UNITED STATES NUCLEAR REGULATORY COMMISSION'S
ADVISORY COMMITTEE ON REACTOR SAFEGUARDS

July 7, 2008

UNITED STATES OF AMERICA
NUCLEAR REGULATORY COMMISSION
ADVISORY COMMITTEE ON REACTOR SAFEGUARDS
(ACRS)
MEETING OF THE THERMAL HYDRAULIC PHENOMENA
SUBCOMMITTEE
PEER REVIEW OF THE TRACE CODE
MONDAY
JULY 7, 2008
ROCKVILLE, MARYLAND

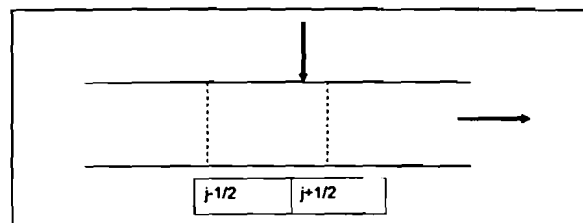
- The code developers have modified the momentum flux terms in Version 5.07 in response to this review, such that the velocity that is nearest the solid surface is set to zero for connections that are at 90 degrees to the solid surface. Thus the momentum gradient term:

$$j\nabla V = \frac{0.5 * (V_{j+1} + V_j)(V_{j+1} - V_j)}{\Delta x_{j+1/2}} \quad \text{becomes:}$$

$$j\nabla V = \frac{0.5 * (V_j)(V_j)}{\Delta x_{j+1/2}} \quad \text{if } V_{j+1} = 0 \quad \text{and:}$$

$$j\nabla V = \frac{0.5 * (V_{j+1})(V_{j+1})}{\Delta x_{j+1/2}} \quad \text{if } V_j = 0$$

Film condensation

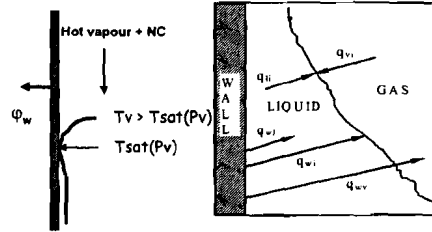
- > The enhancement of the condensation due to ECCS jet induced turbulence should be modelled in TRACE and validated in a separate effect way.

- > A model for "overheated condensation" should be implemented to allow starting condensation in single phase overheated steam or gas mixture when $T_w < T_{sat}(P_v)$
- > This should use q_{wi} to create liquid.
- > Then when some liquid film exists, condensation can be treated by q_{wi} and q_{li} .

TRACE VESSEL Cartesian Elbow

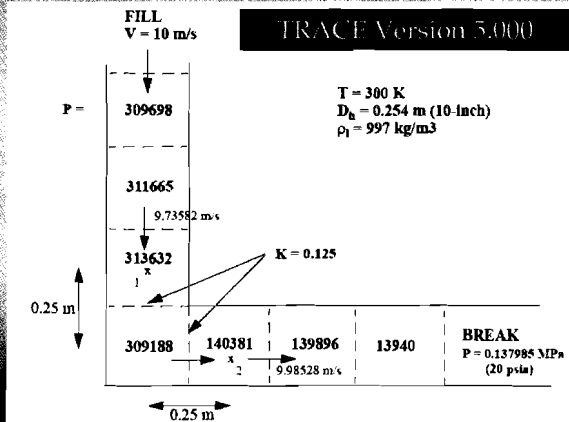
- TRACE Version 5.000
ΔP = 25.1 psi
- Hand Calculation
ΔP = 1.6 psi
- TRACE Version 5.007
ΔP = 3.5 psi
